Annexure A

Tripping of 400 kV Meramundali - JSPL Ckt 1& 2

Report on the grid event in Eastern Region (पूर्वी क्षेत्र में ग्रिड घटना पर रिपोर्ट)

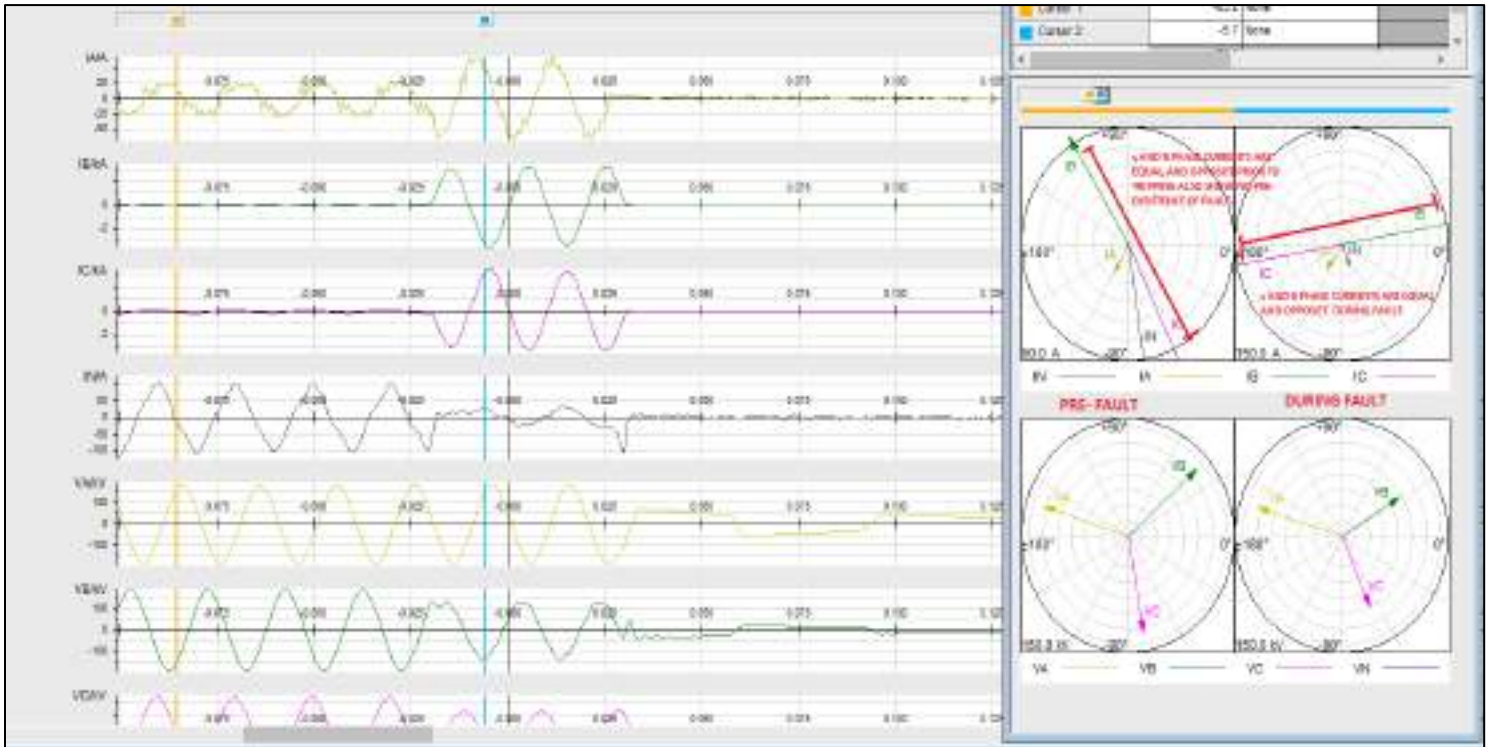
AT CHARGING INSTANCE: Then at the charging instance after few milli line tripped due to Y-B fault and it appears from DR that prior to tripping B phase fault converted to Y-B fault and was existing in the line with small magnitude which increased in few milli seconds and got detected and tripping issued .

Similar phenomenon is also observed in the past this may be checked that what nature of fault is occurring where first B phase fault is being converted to Y-B phase fault with some small arcing kind of phenomenon leading to Phase to phase conversion. Whether any Row or clearance issue is there?

Tripping of ckt-2 on 19th August

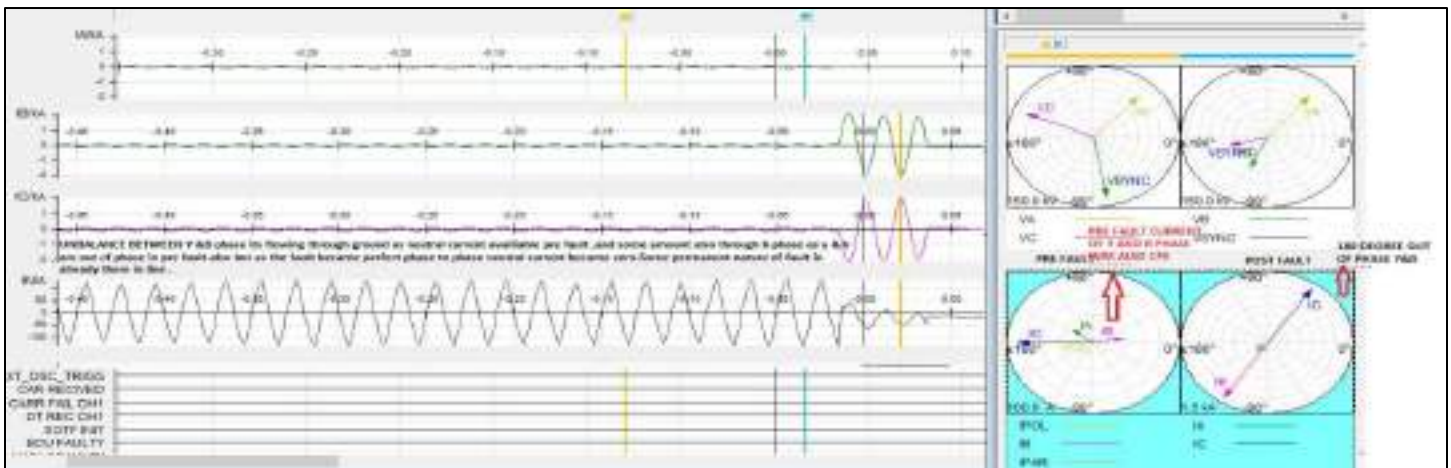
Similar incident was also observed in one past case also where line tripped on B phase fault and while charging Y-B phase fault observed .At the charging instance similar phenomenon observed where Y-B fault was pre-existing it was already having some permanent nature of fault shorting both phases but after few milliseconds it got converted to perfect phase to phase Y-B fault with Y & B currents 180 degree out of phase and current also increased up to 1.5 ka and line tripped.

.Please refer DR as shown below for 19th august tripping at the time of charging.

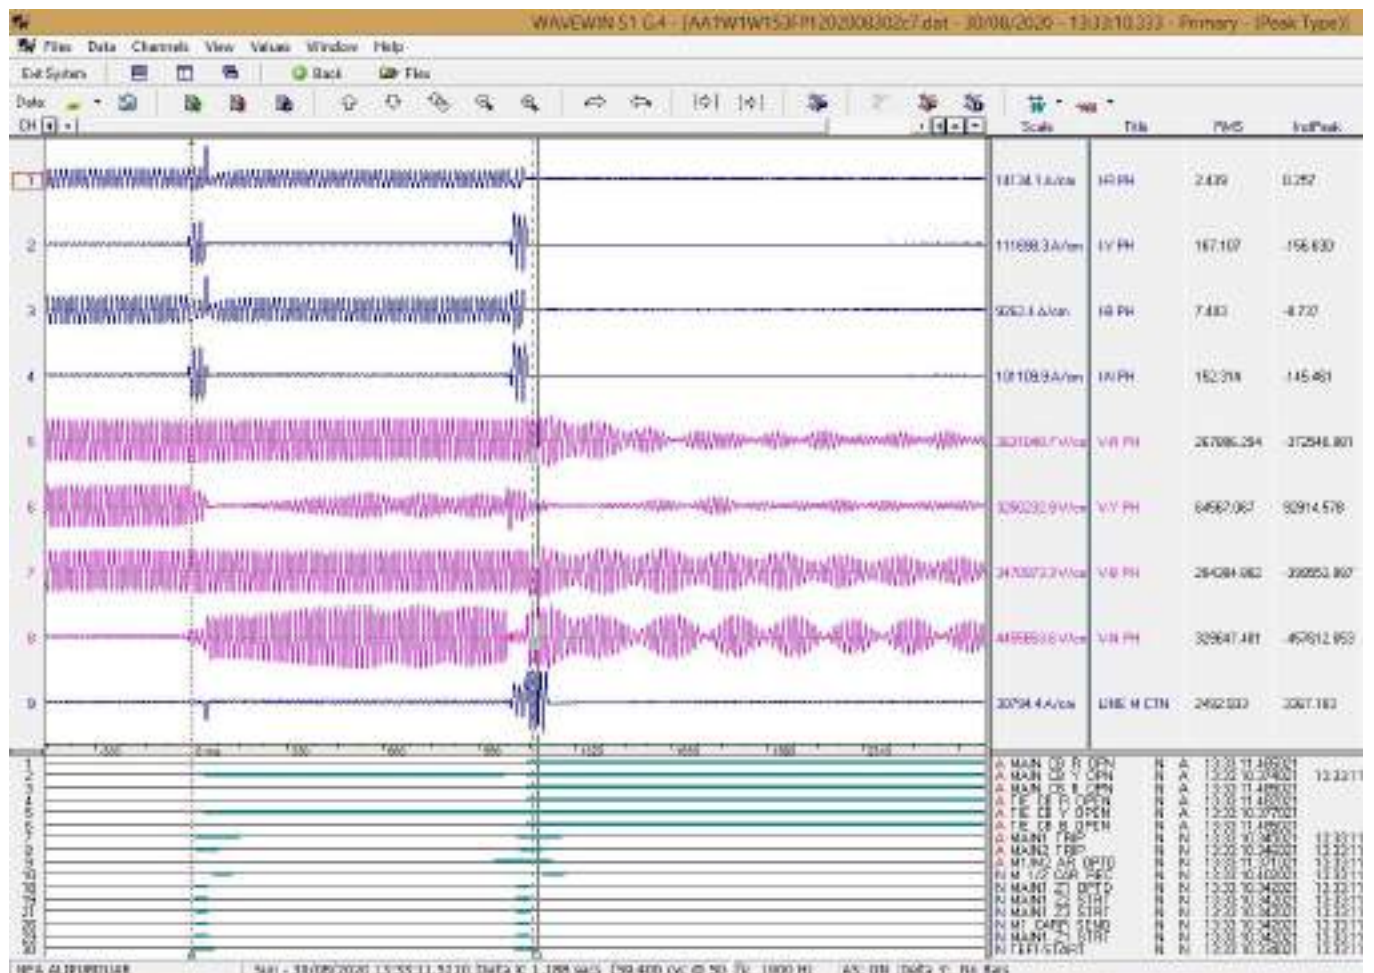
Problem of ferro-resonance observed during Single phase tripping of 400KV Binaguri-Alipurduar Ckt.-I&II due to over compensation. Initially those lines are as 400KV Binaguri-Bongaigaon D/C having distance of 217KM with Line Reactors of 50MVAR in each circuits at Binaguri end; later both the lines are LILO at 400KV/220KV Alipurduar substation having new distance of 123.7KM from Binaguri end.

Due to ferro-resonance problem, the voltage in healthy phases shoot up to 291 KV (Ph-N) i.e. approx. 1.26 times of normal voltage and the neutral voltage up to 366KV. This will create stress in healthy equipment like- CT, CVT, WT, LA etc and may deteriorate the life of costly equipment.

Both the 50MVAR Line Reactors are switchable in nature and hence Reactor CB to be given 3-ph trip command in case any single phase operation of Line Protection, so that Line Reactor will be out of service to avoid resonance problem.
